From: Klatt, Jeremy <jeremy.klatt@dnr.iowa.gov>
on behalf of Klatt, Jeremy <jeremy.klatt@dnr.iowa.gov>
<jeremy.klatt@dnr.iowa.gov>
To: Brian Jergenson
<brian.jergenson@dnr.iowa.gov>; Book, Kelli
<kelli.book@dnr.iowa.gov>; Joe Sanfilippo
<joe.sanfilippo@dnr.iowa.gov>
Cc: Trent Lambert
<trent.lambert@dnr.iowa.gov>
Bcc:
Subject: Re: Supreme Beef MMP Reviews
Date: Thu Nov 19 2020 08:32:31 CST
Attachments: image.png
image.png

Well - I took a look at the SDR (sediment delivery ratio) for these fields without terraces and Steve is correct, the SDR is not appropriate. There are 7 fields that look to be problematic - these 7 fields had a terrace credit taken in the initial submittal and, unfortunately, I must not have verified the SDR value after the terraces were removed.....

Figure 2, Sediment Delivery Ratio Factor

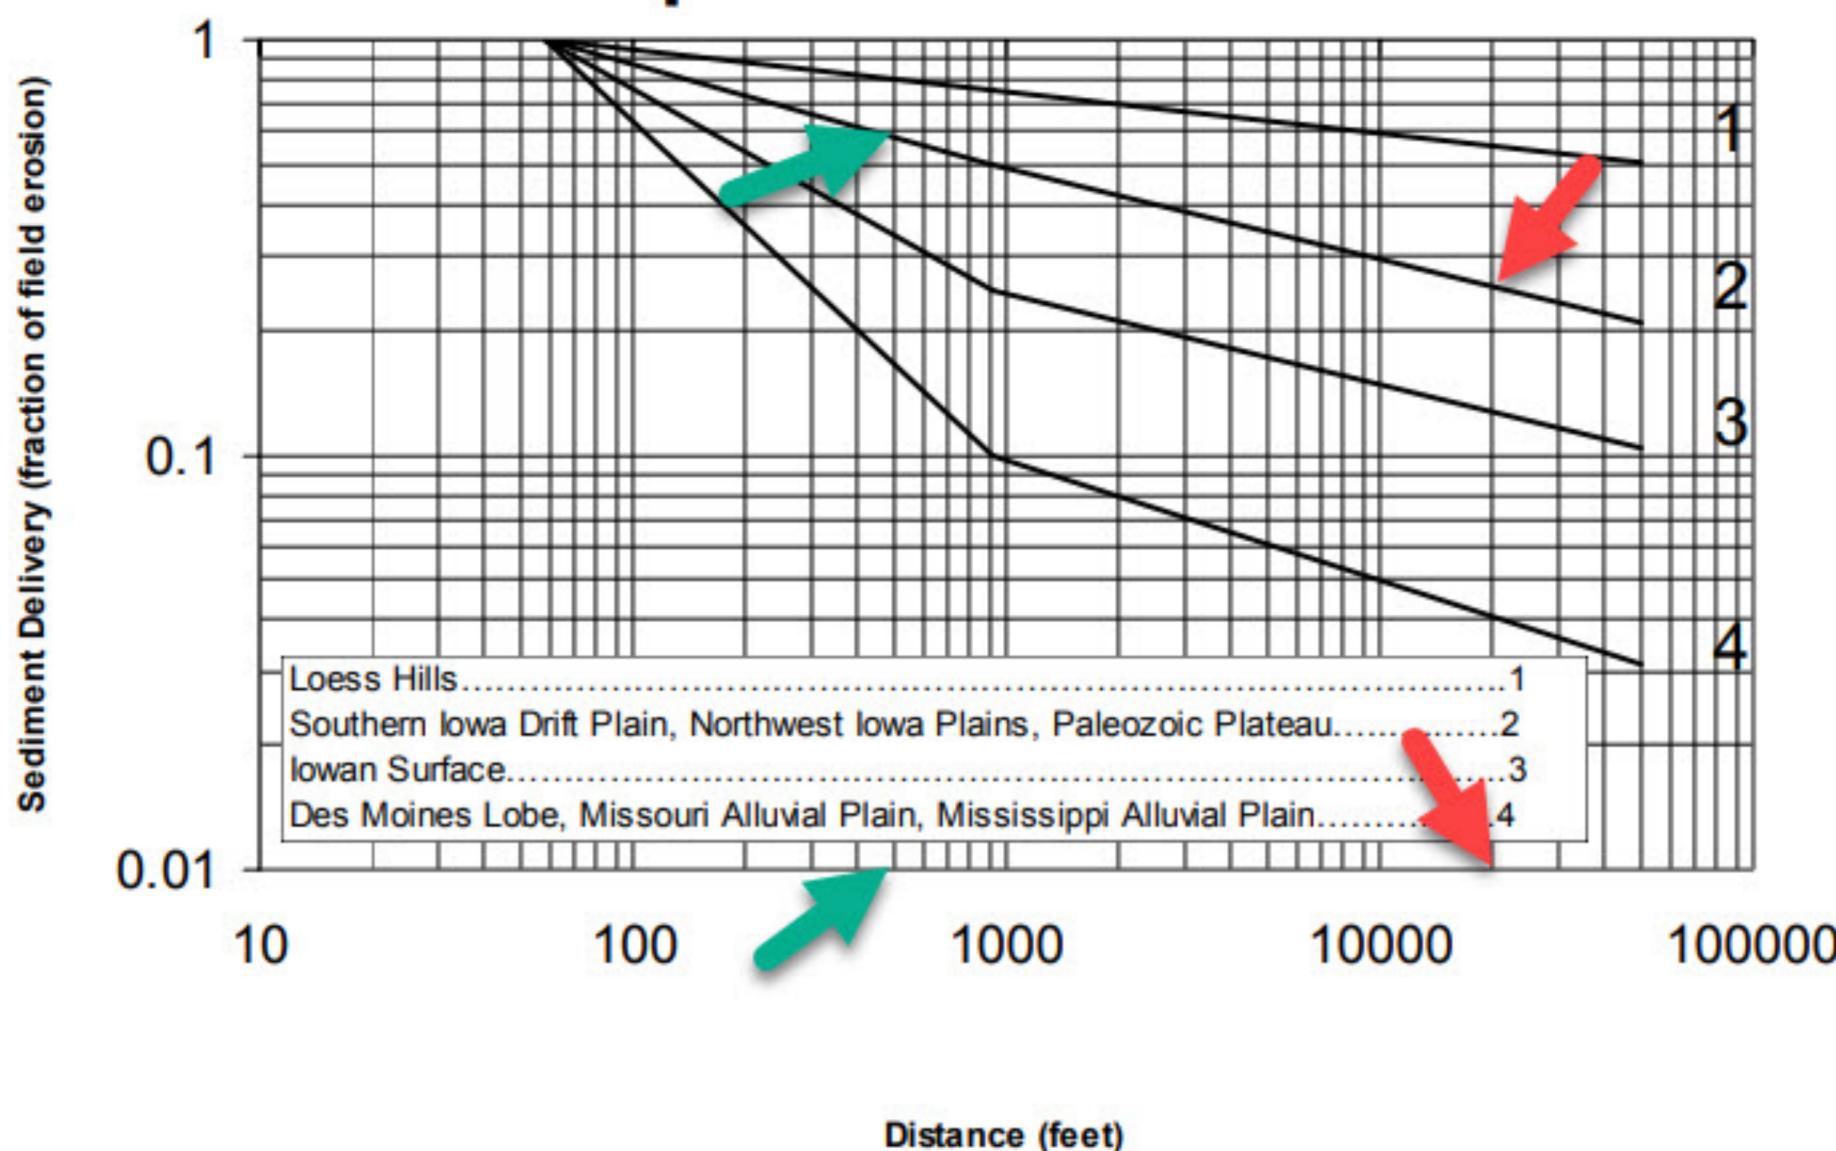
I'm immediately concerned about the SDR values chosen in the P-Index equations for fields that are not claiming terraces. For those fields they use STF instead of SDR. (I have issues there as well). When I look carefully at Figure 2 in Iowa Technical Note 25 (attached), which is the rule referenced document in IAC 65.17(17) for nutrient management plans, the values I see for SDR for many of the fields (0.22, 0.23, et cetera) would seem to indicate that field centers are 10,000-20,000 feet away from the nearest perennial or intermittent stream; see page 3 of Technical Note 25, the paragraph about Sediment Delivery Ratio. I'm not sure ANY field in NE Iowa is 10,000-20,000 feet from surface water! The first field I checked in the plan (labelled "Across the Road") is only a few hundred feet from a stream. This would yield an SDR closer to 0.5 or 0.6, which would change the P-Index calculation significantly, and

might disqualify that field. See attached graph with red arrows indicating claimed SDR and distance to water, and green arrows indicating SDR if distance to water is 500 ft. I will fine tune this value in one direction or the other when I load the latest USGS NHD Plus HR stream coverage. The LIDAR image for the "Across the Road" field is from the DNR AFO Siting Atlas. Note the measured distance of about 600 feet from an intermittent stream directly connected to a perennial stream, Honey Creek. Note all the green dots, representing sinkholes in or near the field. This is a field where manure should be applied? Admittedly, I've not found an agronomist yet to review and check my observations, but that effort continues.

The SDR is a function of the landform region and the distance to the nearest stream - really quite difficult to mess that up and I'm not sure how Becky missed the mark so badly. But anyway - correcting these values is going to increase P index and is going to reduce application rates in these fields. I believe a couple of the fields might end up being >5 (i.e. no application allowed).
